566-594 Princes Highway, Kirrawee

RESPONSE TO DEPARTMENT OF PLANNING & ENVIRONMENT  
CORRESPONDENCE DATED 3 SEPTEMBER 2014

Section 75W Modification (MOD 3)  
to Concept Plan MP10\_0076

Modification of Approved Envelopes (MOD 3)

Figure 1:

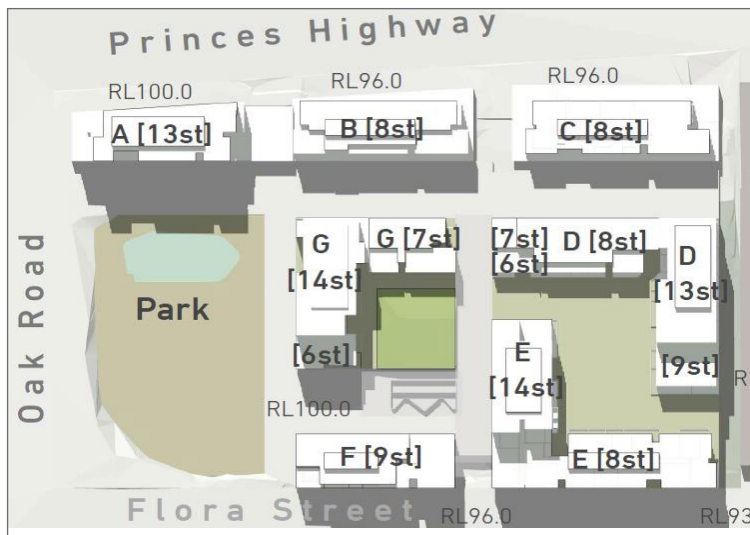
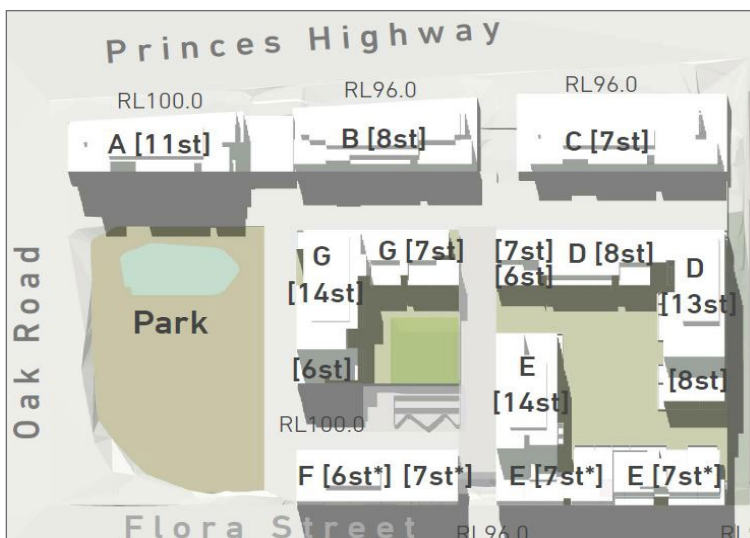
- reduction in the height of Building F adjacent to Flora Street from 9 storeys down to 6 storeys at the western end and 6 storeys plus a setback part floor (7 storeys) at the eastern end;
- reduction in the height to Building E adjacent to Flora Street from 8 storeys down to 6 storeys plus a setback part floor (7 storeys);
- reduction in the height of Building A from 13 storeys down to 11 storeys (above RL 100) (the documentation has also been updated to correctly reference the number of occupied floors).
- decrease in total and residential GFA, indicative apartment numbers and indicative car parking numbers

Issue	Response
Height on Flora Street	
<p>The Department is concerned that the 9 storey buildings envelopes fronting Flora Street are out of scale within the intended future character of the Flora Street streetscape. Furthermore, the 9 storey building envelopes would overshadow the development sites on the southern side of Flora Street and therefore impact on the future development of those sites.</p> <p>The Department recommends that the 9 storey envelopes be reduced in scale and suggested the provision of 6 with a setback 7 storey building envelopes in this location.</p>	<p>The proposal has been amended to reduce the height of Building F adjacent to Flora Street from 9 storeys down to 6 storeys at the western end and 6 storeys plus a setback part floor at the eastern end. The height to Building E adjacent to Flora Street has also been reduced from 8 storeys down to 6 storeys plus a setback part floor. The amendments fulfil the specific suggestion from the Department. Accordingly, the amended proposal has approximately the same street wall height as that which has already been approved under the existing Concept Plan and is of a scale which is compatible with the future character of Flora Street.</p> <p>In addition, the significant reduction in height ensures that only minimal overshadowing of the very front of the sites on the southern side of Flora Street will result from the proposed amended Concept Plan. Accordingly, a variety of development options could now be undertaken on those sites which achieve the minimum required 3 hours of solar access to 70% of apartments.</p>

Amended scheme
